Access Compliance Report

Public Rights-of-Way

Intersection ID: N/A	Main Street: BARRINGER_DR	Cross Street: BRENTWOOD_PL	Location: SW
ADA ID: 906287F711D6	Ramp Type: Perp	Initial Pass/Fail: Fail	Overall Compliance: No
		Severity Score: 25

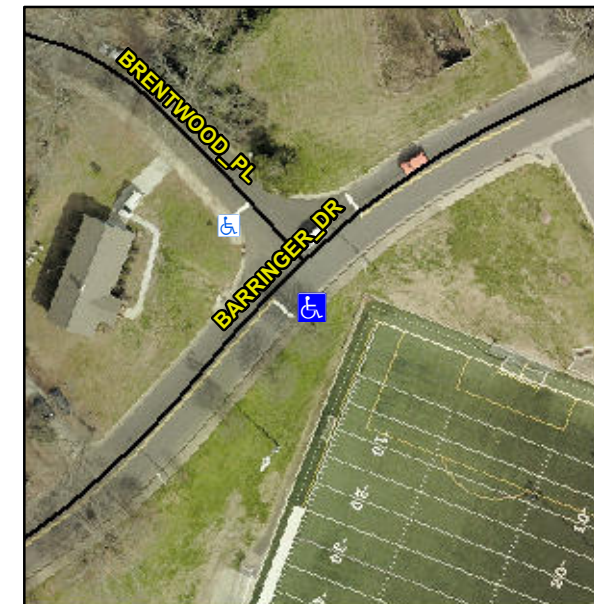
Not Found, R304.2.2, R304.5.3

Compliance	Description	Data	Compliance	Description	Data
N/A	Ramp Length (in)	60.0	No	Ramp Slope (%)	9.6
Yes	Ramp Width (in)	49.0	No	Ramp XSlope (%)	5.6
N/A	Flare Type LT	N/A	N/A	Flare Type RT	N/A
N/A	Flare Slope LT (%)	N/A	N/A	Flare Slope RT (%)	N/A
N/A	Flare Traversable LT?	N/A	N/A	Flare Traversable RT?	N/A
N/A	Landing Length (in)	N/A	N/A	DWS Provided?	N/A
N/A	Landing Width (in)	N/A	N/A	DWS Contrast?	N/A
N/A	Landing Slope (%)	N/A	N/A	DWS Length (in)	N/A
N/A	Landing X Slope (%)	N/A	N/A	DWS Full Width?	N/A
N/A	Landing Curb? (Y/N)	N/A	N/A	DWS Offset (in)	N/A
N/A	Shared Landing?	N/A			
N/A	Gutter Ponding?	N/A	N/A	Gutter Slope (%)	N/A
N/A	Gutter Lip Ht (in)	N/A	N/A	Gutter X Slope (%)	N/A
N/A	Painted X Walk1?	No	N/A	Painted X Walk2?	N/A
	X Walk 1 Direction	To N		X Walk 2 Direction	N/A
N/A	X Walk 1 Width (in)	N/A	N/A	X Walk 2 Width (in)	N/A
	X Walk 1 Slope (%)	3.6		X Walk 2 Slope (%)	N/A
	X Walk 1 X Slope (%)	4.3		X Walk 2 X Slope (%)	N/A

Remove & Replace Entire Ramp.
